J. H. FLETCHER & CO. Box 2187 – Huntington, WV 25722-2187 – 304/525-7811 – FAX 304/525-4025

INFORMATION BULLETIN NO. 94

**SUBJECT: FLETCHER OPERATOR CANOPIES**

### DRILLER CANOPY SUPPORT POST

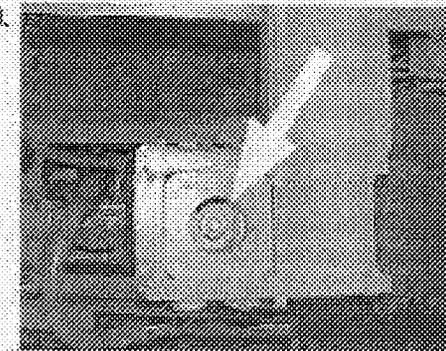
Failure in the connection between the cylinder and tubing can result in an unexpected drop in the driller canopy at some point after the CANOPY control lever is operated in the "canopy lower" direction.

This bolt must be checked weekly – making sure it is in place and properly tightened.

Whenever re-assembling the driller canopy support post assembly, always use a genuine Fletcher OEM replacement bolt and tighten to 150 ft-lbs.

**CAP WITH  
O - RING**

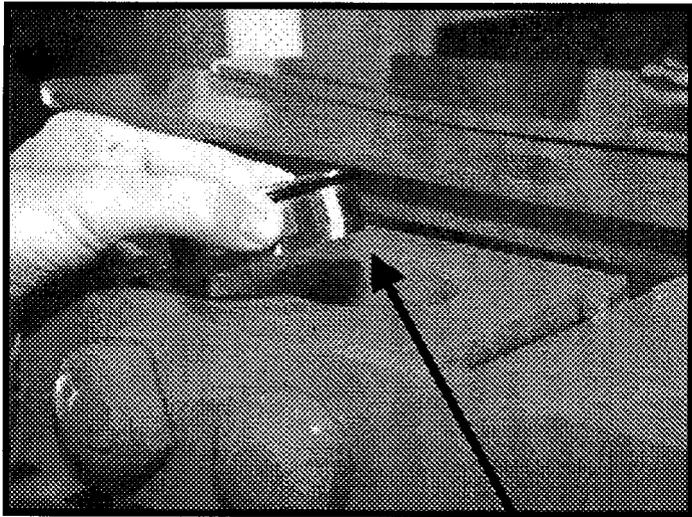
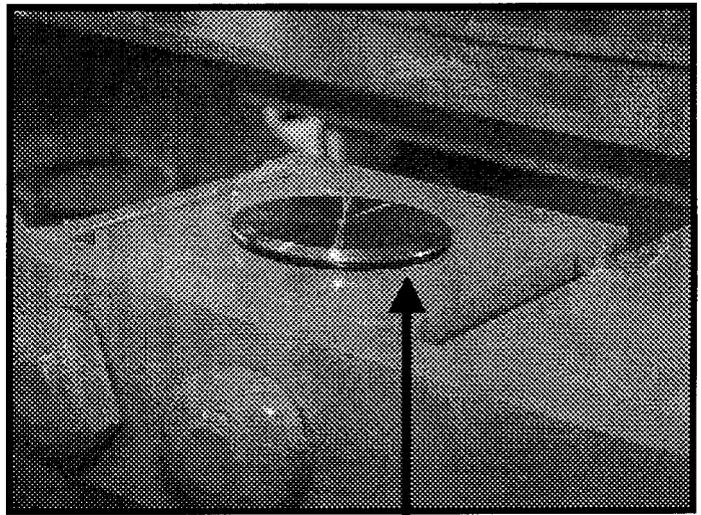
Fletcher now offers a cap (part number: 381113) to prevent dirt and debris from filling up the bolt access hole, providing quicker and easier access to the canopy bolt for inspection (see Attachment 2).

**SUPPORT POST – ALTERNATIVE DESIGN**

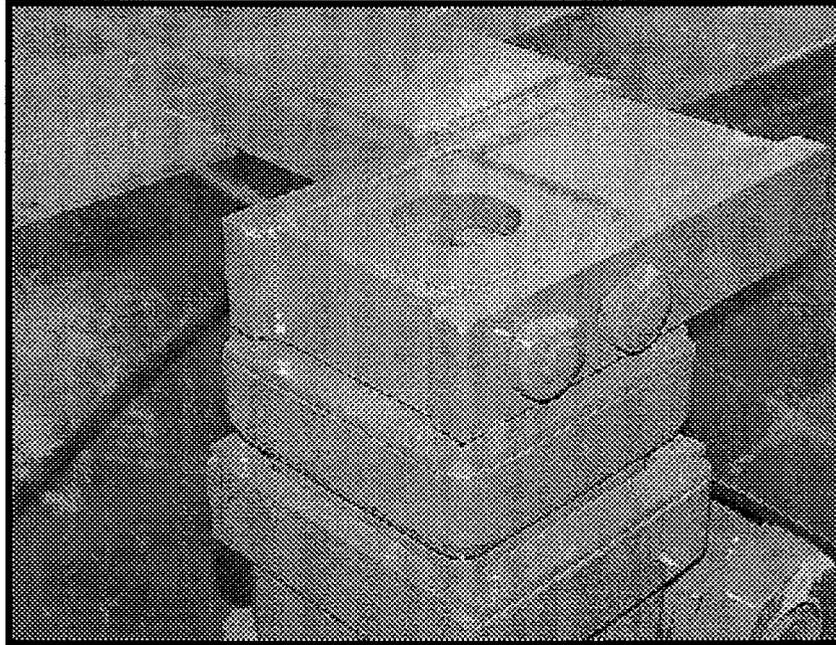
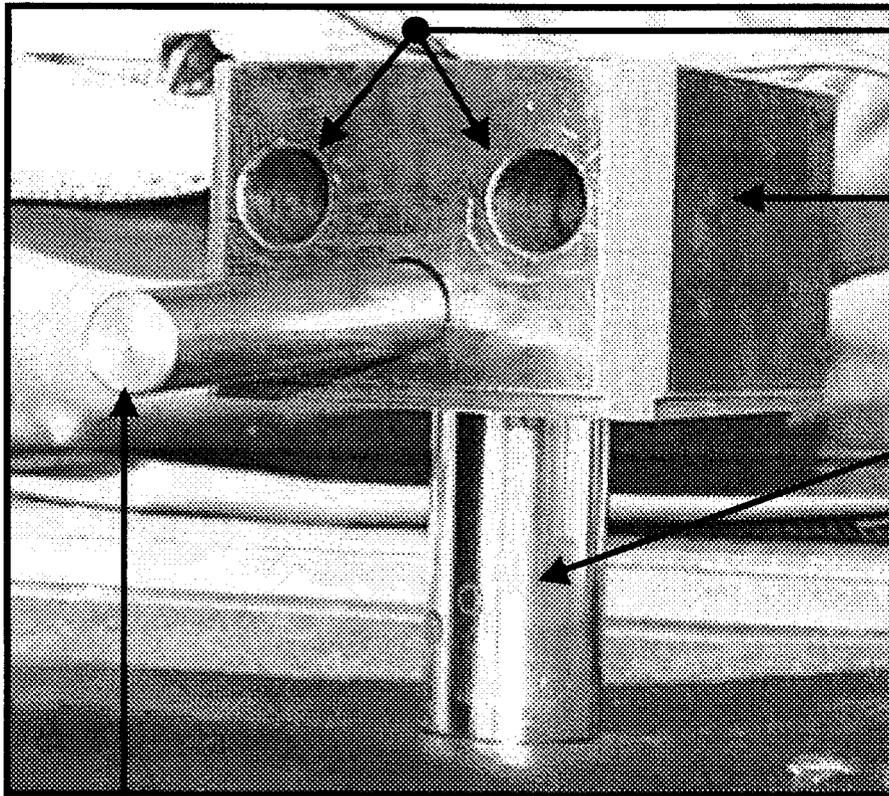
As an alternative to the existing design that requires the bolt torque inspection, Fletcher has developed a support post and cylinder design that eliminates the bolt altogether (see Attachment 3). The new design uses a pin to connect the cylinder rod to the support post inner tube. The pin is held in place by the canopy or support post cap. You can exchange your existing post and cylinder for this new design through our service department or an authorized distributor, or upgrade it during your machine or boom modernization. This new design will be installed on all new Fletcher equipment.
